**Hunterston B - Return to service safety case for Reactor 4 following core inspection results in 2018 - NP/SC 7785 - Civil engineering assessment**

Assessment Report ONR-OFD-AR-18-085  
Revision 0  
April 2019

Figure 2 – New PCPV Model idealisation

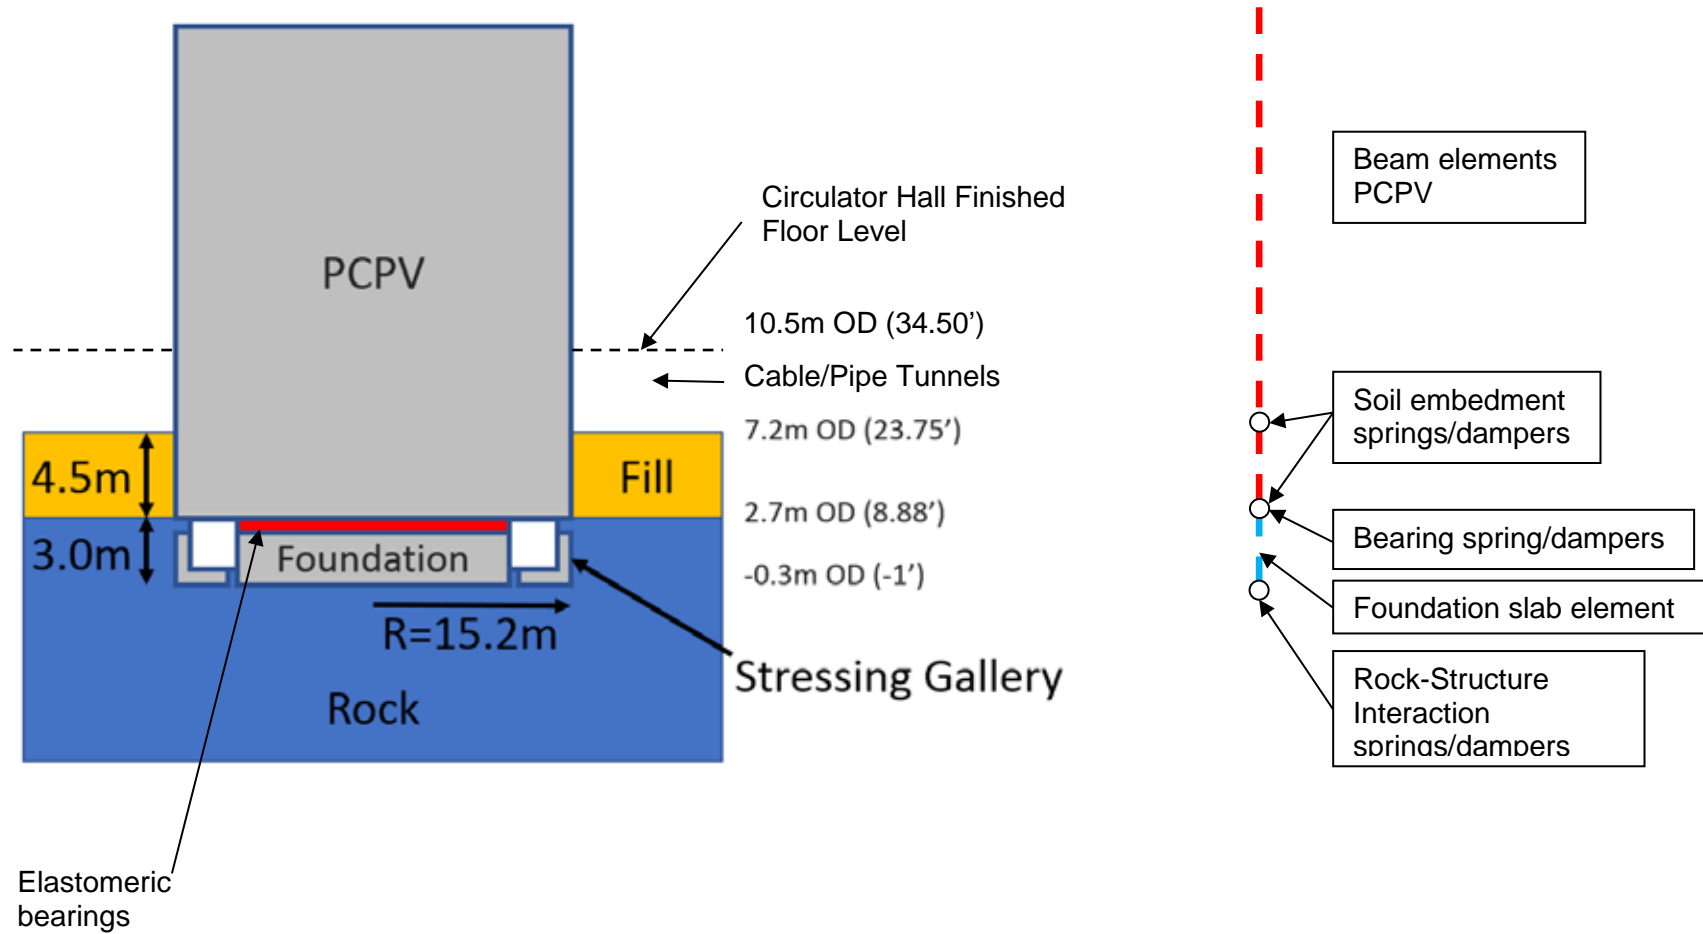
71. The preliminary PCPV model is idealised in Figure 2. It is a development of the first seismic “buildings model” produced in support of PSR1. This “legacy” model (see Figure 1) was developed to perform a BE seismic assessment of the structural members of the Reactor Building and Turbine Hall. It included representations of the PCPVs, Central Block, Circulator Hall and ancillary buildings. The legacy model was used to derive acceleration time histories, which were used as the basis for seismic assessments of the graphite cores.
72. One of the key features of the PCPV design is the presence of neoprene bearing pads between the underside of the vessel and the top of the foundation disk. These

Figure 4 - SRS comparison at core boundary for PML synthetic input motion for Legacy and Preliminary PCPV models (After Ref. 17, Figure 33)

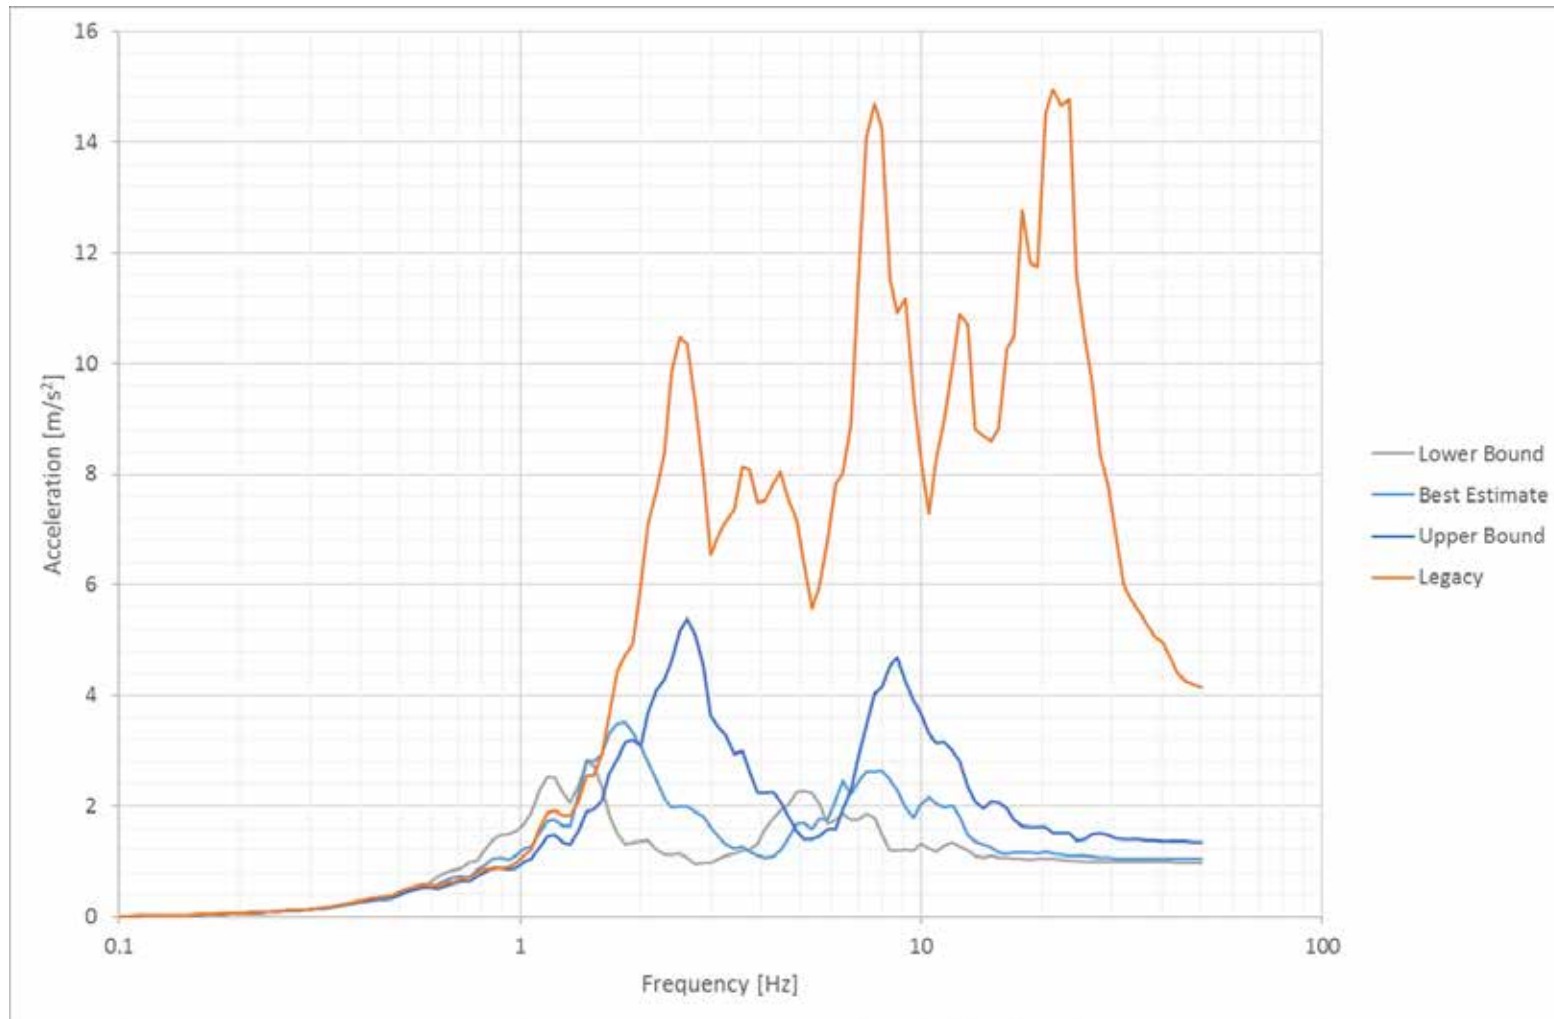
163. I consider it is apparent from Figure 4 that for the BE case, using the synthetic PML seismic input motion, that the spectral acceleration at the core boundary for the preliminary model is less than that for the legacy model at all frequencies above about 1.5 Hz. At lower frequencies, the two models gave similar core boundary accelerations.

164. Figure 4 also shows results for LB and UB sensitivity cases (i.e. in which RSI, bearing and backfill properties are all set to their individual LB or UB values simultaneously). These plots show that the core boundary accelerations are greater in the 2 to 5 Hz region for the UB case compared with the BE case, but remain lower than for the legacy model. For the LB case, the spectral acceleration exceeds that for the legacy model below 1.5 Hz. As part of its response to ABSC Query 2 (Ref. 24), NGL provided further evidence in the form of core distortion scores (an example of which is given in Figure 7) that confirmed that the UB sensitivity case was the most onerous for core distortion. Based on the evidence presented, I am satisfied that the core response is not critical at frequencies below 1.5 Hz.

Figure 6 - SRS comparison at base of PCPV for Preliminary (prelim) and Final models (PML synthetic input motion) (after Ref. 24 - response to ABSC Comment 2i)

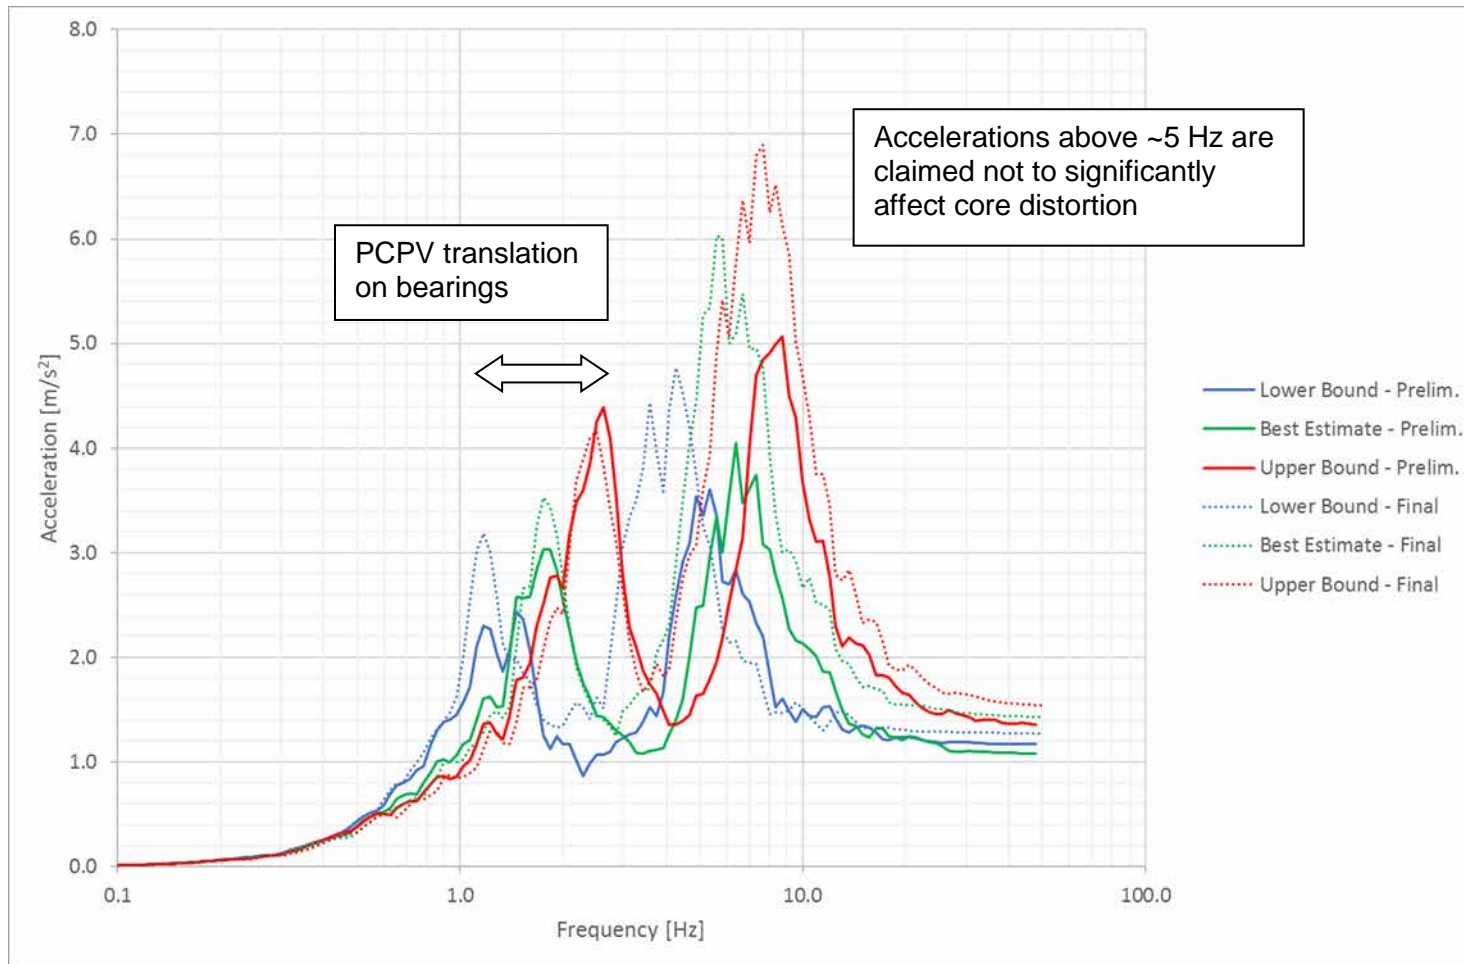
Further details supplied in response to this query (Ref. 24) have elicited information in the form of SRS comparisons for the preliminary and final models (e.g. Figure 6) and preliminary GCORE runs based on the final PCPV model output. These runs include graphs showing margins in relation to interstitial channel distortion (for examples see Figures 7 and 8). As it is not stated on the information provided, NGL has clarified (Ref. 34) that the core state assumed in these analyses was 931 SCB (in layers 3 to 8) and 400 DCB (in layers 4 to 6). It is understood that other core states have been analysed (including the inclusion of MCBs) and these gave similar results, but I consider this a matter for ONR's graphite assessment and outside the scope of this report.

173. The horizontal SRS presented in Figure 6 can be used to assess whether the modelling changes made by NGL to the preliminary model (described in Section 4.3.1.9) in order to create a final model are likely to have a more onerous effect on the core. For the BE case, the low frequency peak increased by around 17%, with the second peak increasing by around 50%. For the UB case, stated by NGL to be governing in GCORE, the low frequency peak is not significantly changed, but the second peak is increased by around 40%. The second peak is associated with the rocking mode, which NGL considers is not critical for core distortion. Although it appears that the effects of the changes to the model may be more onerous for the core, this can only be confirmed by sampling GCORE analysis results, samples of which I obtained as a result of raising queries with the licensee as described below.
